Tax ID # 1405447305  
**ON-SITE SEWAGE DISPOSAL SYSTEM**  
**HOWARD COUNTY HEALTH DEPARTMENT**  
**BUREAU OF ENVIRONMENTAL HEALTH**

Trinity Quality Homes Inc. IS PERMITTED TO INSTALL  ALTER   
ADDRESS: 3075 Park Ave ste 301 PHONE NUMBER: (410) 480-0023  
Ellicott City MD 21013  
SUBDIVISION: CASTLEBERRY AT TEN OAKS LOT NUMBER: 28  
ADDRESS: 4051 CANDLE LIGHT DRIVE, PROPERTY OWNER: TRINITY QUALITY  
DAYTON, MD 21036 HOMES

RE: Septic Variance request for Castleberry at Ten Oaks Lot 28

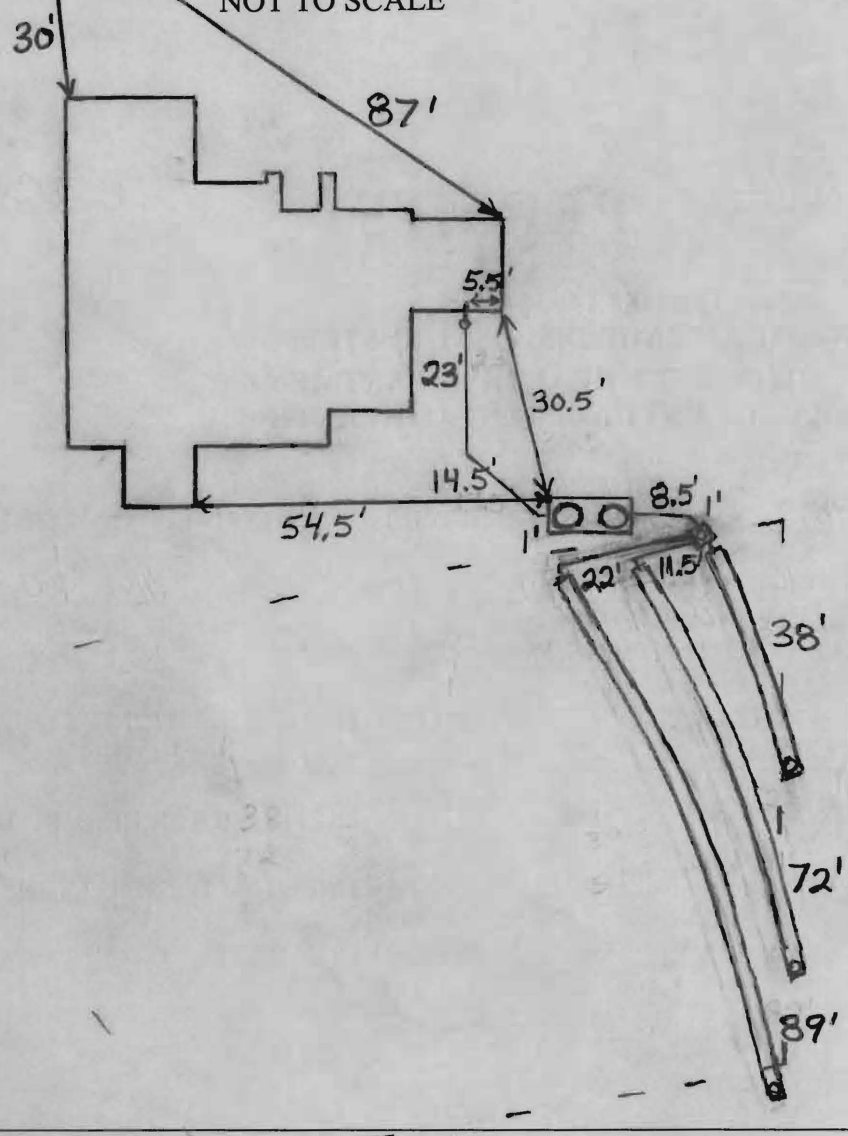
3/7/2012 Layout done. Place the distribution box near the top eastern easement stake. Install a 40', 70' and 90' trench on contour towards the south. Set the tank close to and parallel to the easement near the distribution box. (BB)

INSTALLATION: 3/8/2012 Tank and distribution box set and plumbed in. (BB)

3/9/2012 System finished except for part of bottom trench, O.K. to backfill. (BB)

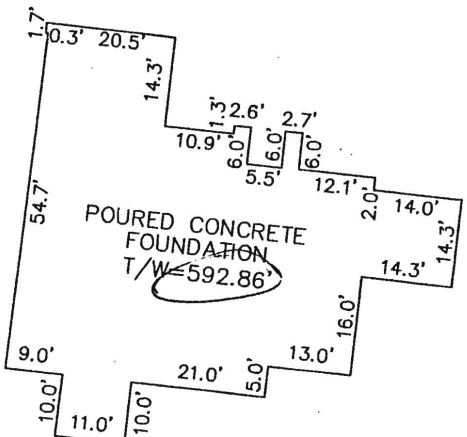
House  
< 20' from  
easement  
& variance approved  
10/20/11

After conferring with Mr. Robert Bricker regarding the septic setback on Lot 28, I am requesting a variance to reduce the setback from the basement foundation to the septic reserve area in the rear of the house on Lot 28 Castleberry at Ten Oaks.

I am requesting a variance, rather than requesting an adjustment to the septic area. This request is to reduce the amount from 20' to 18.5', an amount of 1.5' which is on a parallel slope.

The house cannot be moved forward on the lot because of the position of the well.

10/28/11 Approval  
M T Davis
